CITY OF TUCKER

ITB 2024-010

TUCKER TOWN GREEN CONSTRUCTION

ITB 2024-010
ADDENDUM #2

DRAWING SUPPLIED BY AT&T FOR REFERENCE ONLY

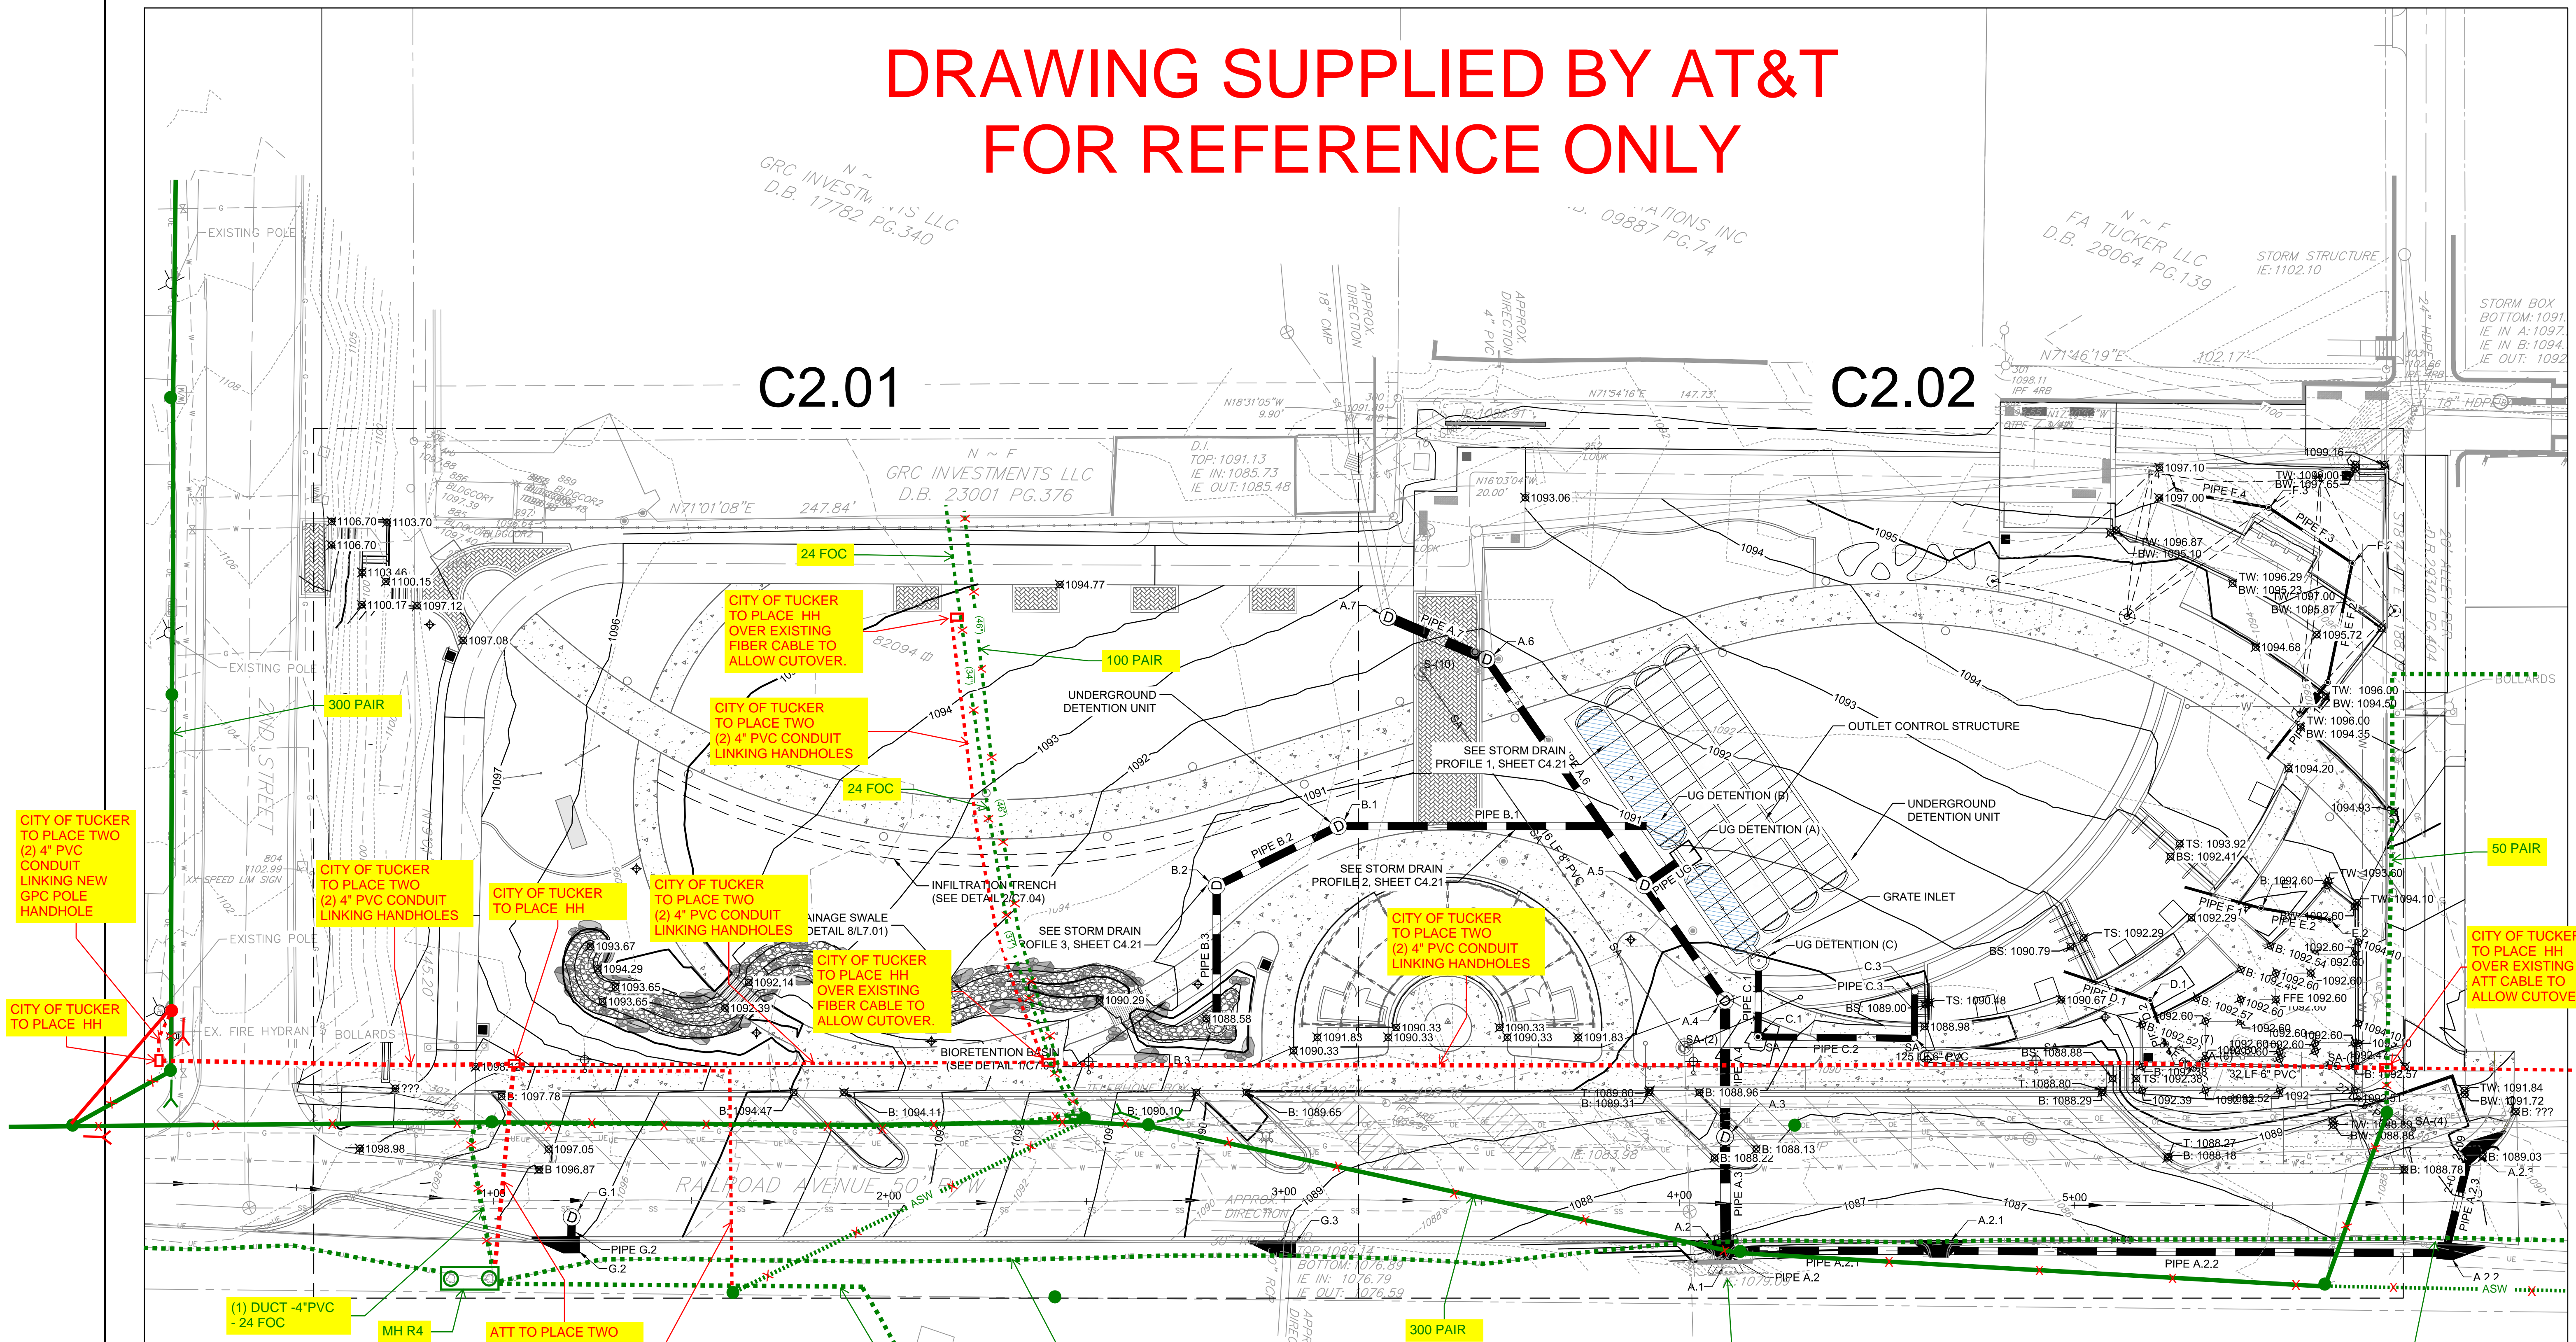
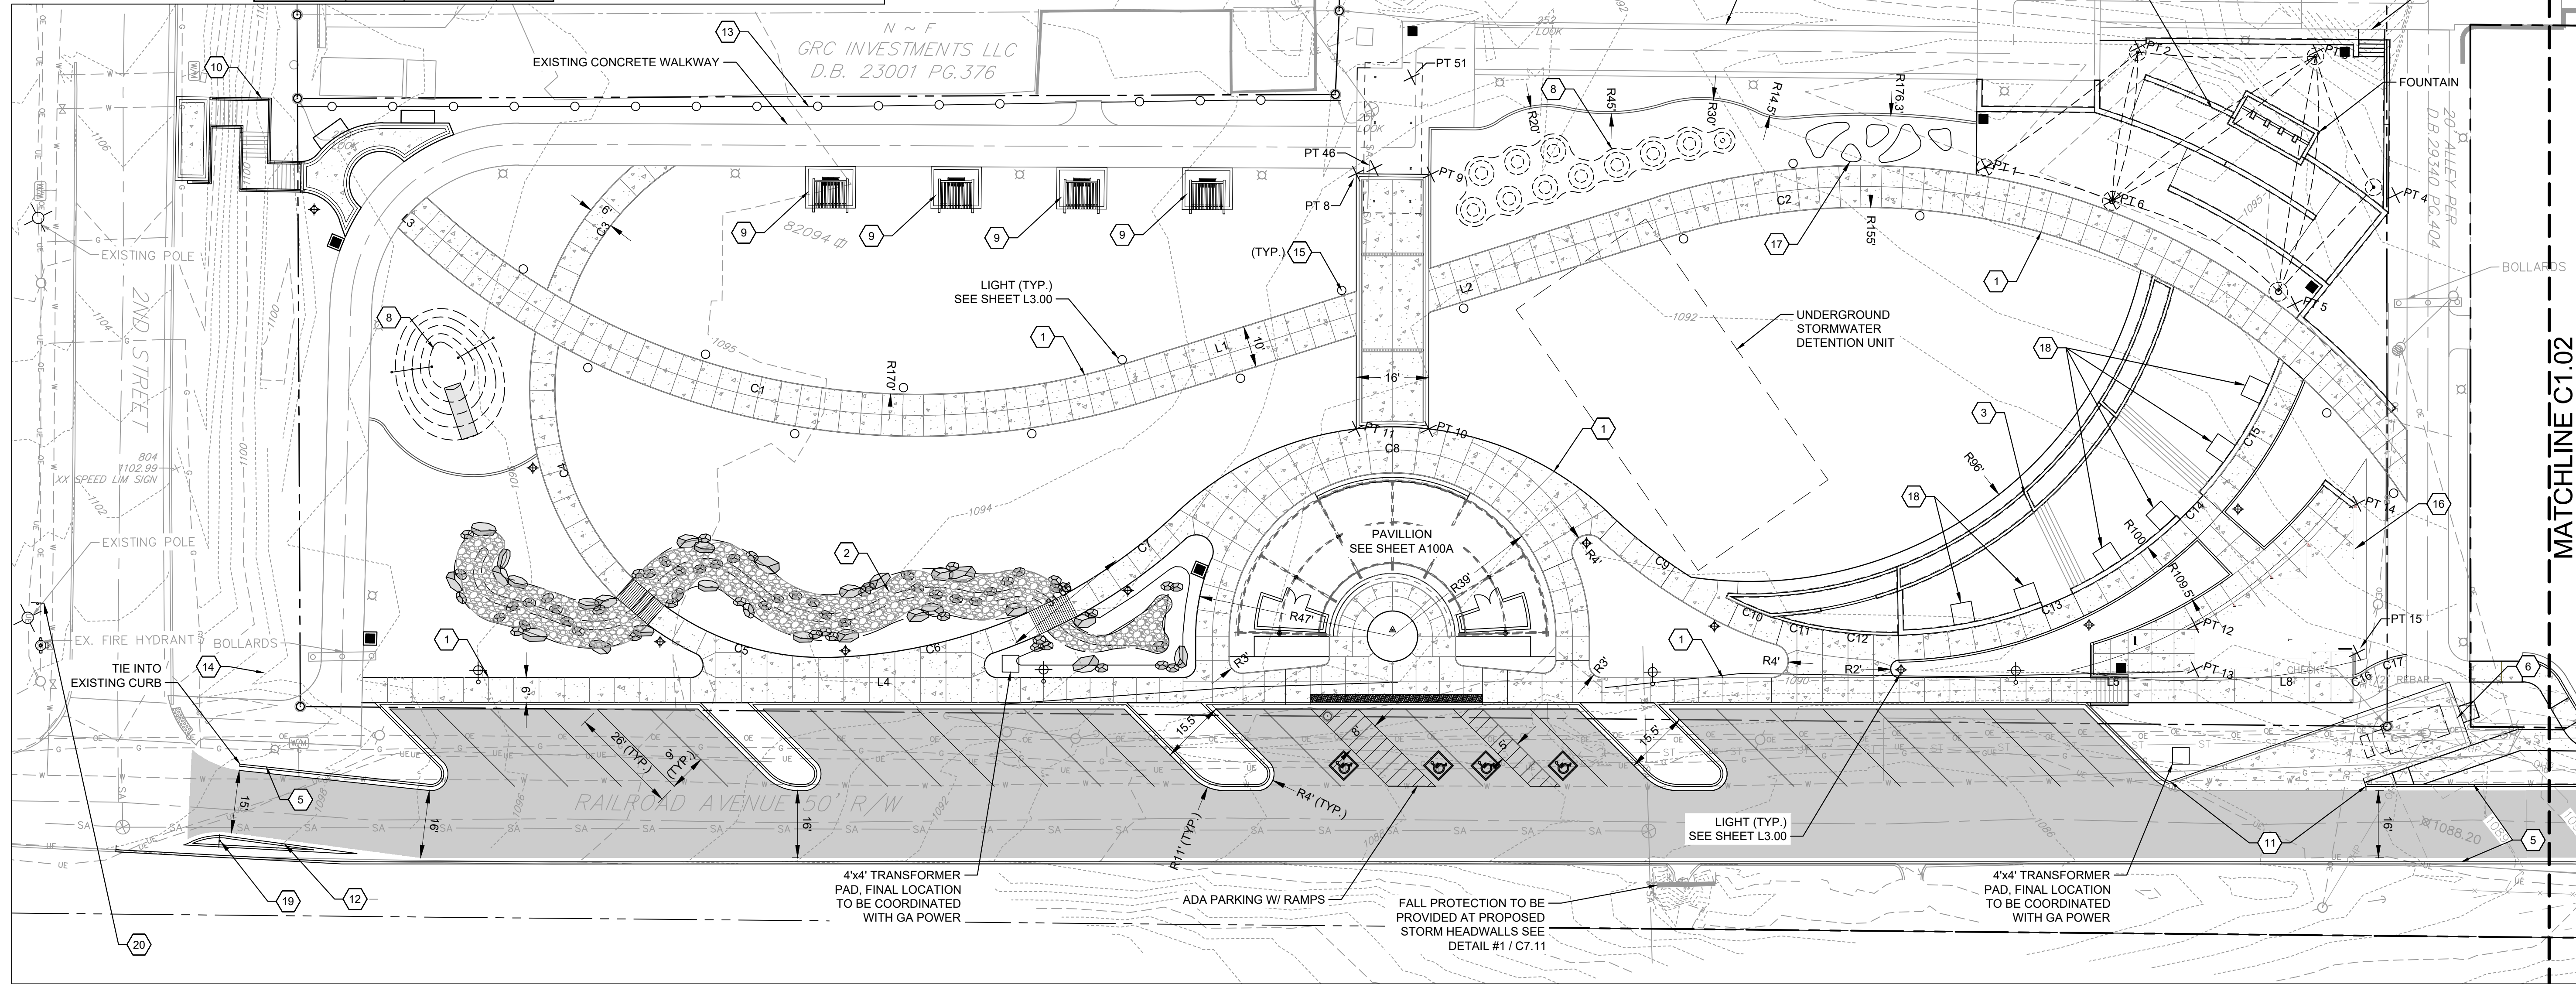
- Clarification about the compactor.
 - Please note: The compactor and the compactor remote power unit will be provided and installed by DeKalb County Sanitation.
- Clarification regarding ATT coordination:
 - Contractor is to install all underground conduit as seen on the concept drawing provided by AT&T (shown in dashed red). Contractor shall retain a design/build entity to finalize the design drawing and obtain formal acceptance from AT&T prior to construction activities. All work must be accepted by AT&T prior to city acceptance.
 - See attached ATT UTLP MARKUP Document
- Responses to Questions
- Revised drawings:
 - C1.01
 - C1.02
 - C7.11
 - L2.01
 - L2.02
 - L7.04

ATT REQUESTS CITY OF TUCKER TO ADJUST PROPOSED STORM DRAIN AS NECESSARY TO PREVENT CONFLICT WITH ATT DUCT.

C1.01
 PROJ. NO. : 3808805

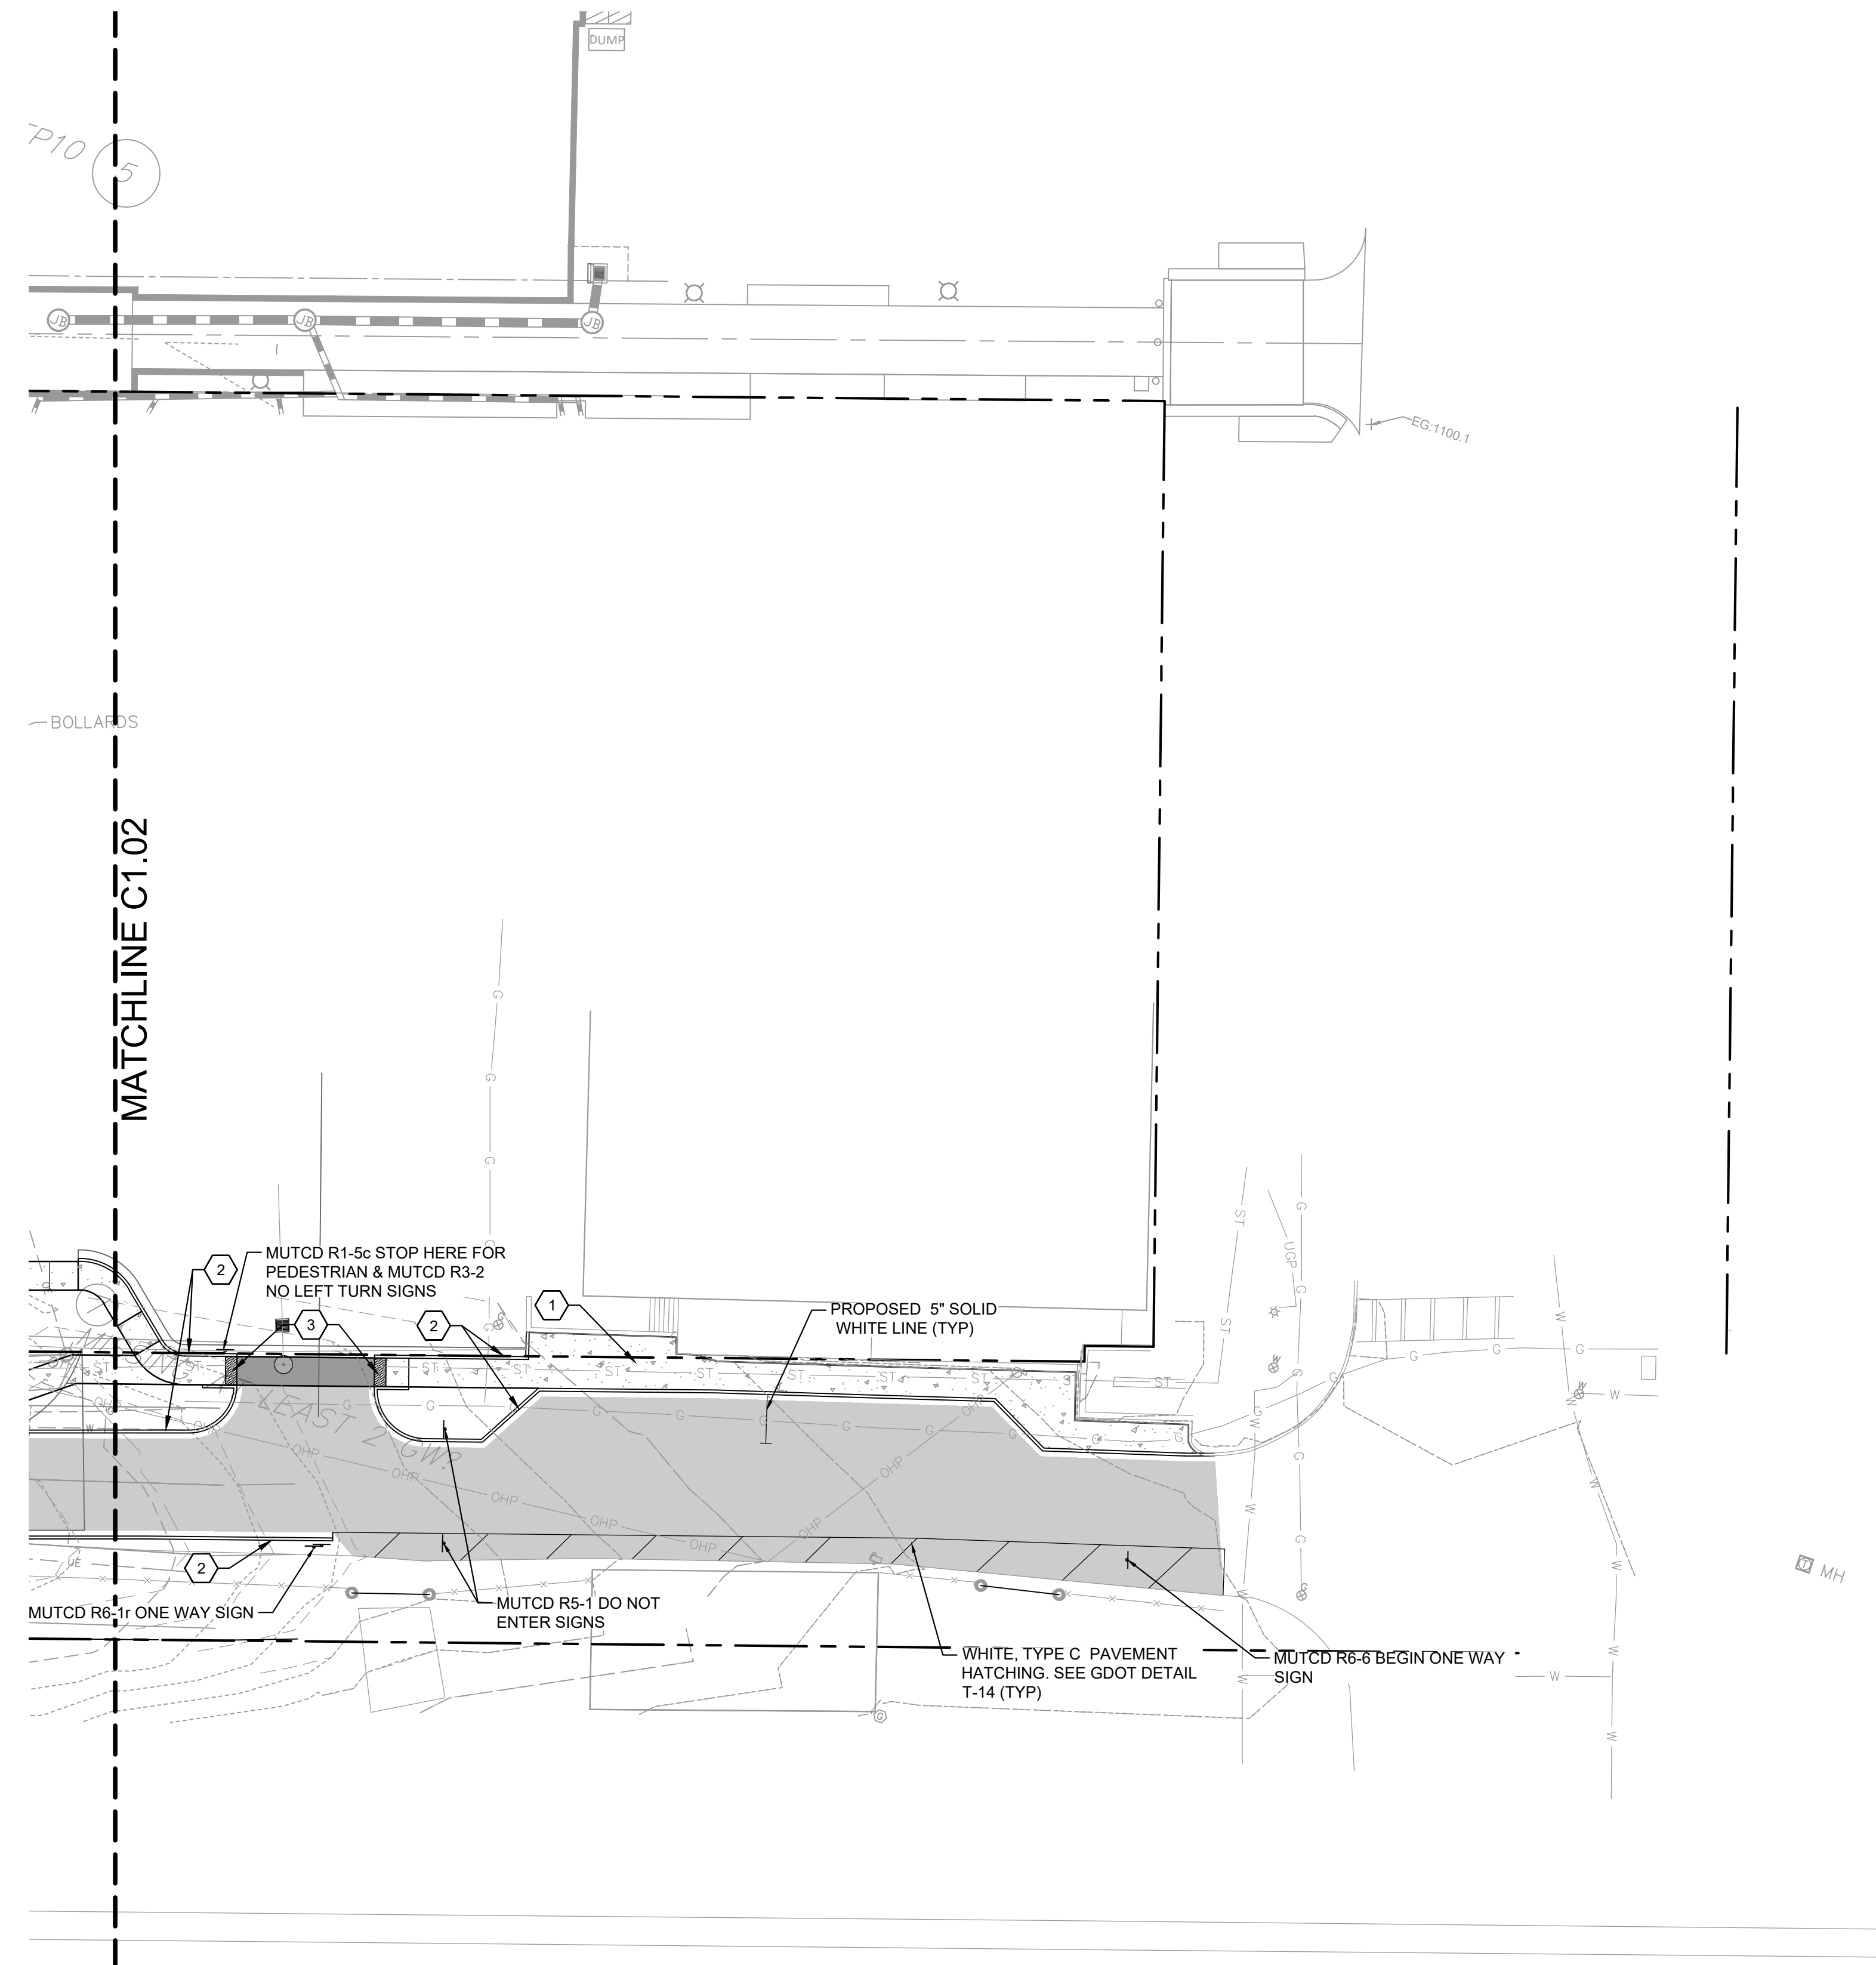
6	Will there be a Noise Ordinance that must be observed during construction?	The noise ordinance codes are in the bid manual.
7	On sheet C1.01, there are two (2) areas [8] Recreation Berms on the plan. What is the correct Recreation Berms area and what is the other area supposed to be labeled as?	Both areas are recreational berms. Please reference L2.01, L2.02, L7.04 and L7.05
8	Where are the Swing Pads located on the project plans?	Reference Sheet L2.01 (SF-102), and Detail 5/L7.03
9	Where are the Mountable Curb and Gutters located on the project plans?	Sheet C1.01 & C1.02 have been revised, see attachment within this addendum to address location of Mountable Curb in the southwest on Railroad Ave. & 2 nd St.
10	On sheet C1.01, there is an area labeled “Fall protection to be provided at proposed storm headwalls.” What are the details for this proposed Fall Protection?	Reference Detail #1 / C7.11 for fall protection to be installed in headwall, this was revised in this Addendum and attached.

11	On sheet C1.02, what are the striped hatched lines on the South side of Railroad Avenue supposed to be?	Roadway striping. Refer to GDOT T-14 Detail ‘C’ (White)
12	On sheet C1.02, there is an icon that looks like highway signage on the bottom right side of the page. Is this to	Sheet C1.01 & C1.02 have been revised, see attachment within this addendum to address signage that wasn’t labeled and additional signage added within this addendum.
